TECHNICAL UPDATE

No. 254

Unifying lengths of Key blades

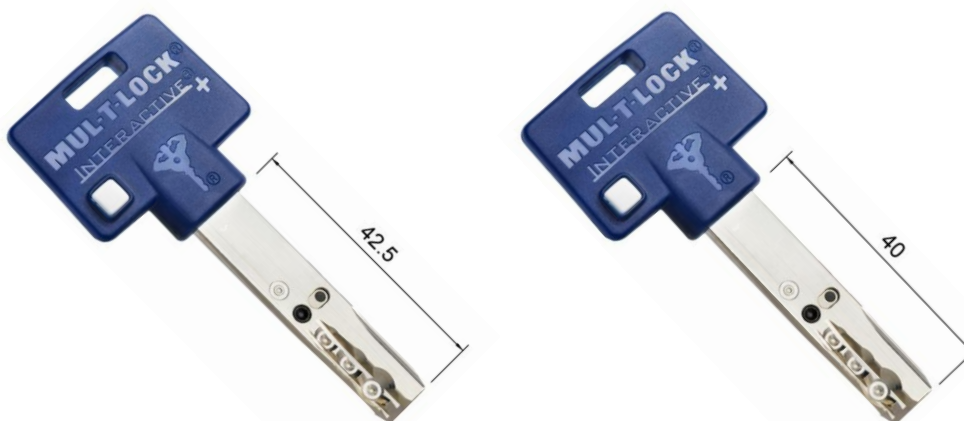
Currently we are supplying 3 different lengths:

38.5 mm, 40 mm & 42.5 mm.

In order to adapt our key blanks to market demands and achieve better production efficiency we have decided to unify the length of 38.5 to 40 mm.

As a result from this change there will be only 2 lengths available: 40 & 42.5 mm.

This change is applicable to all platforms and effective from 4/11/2012
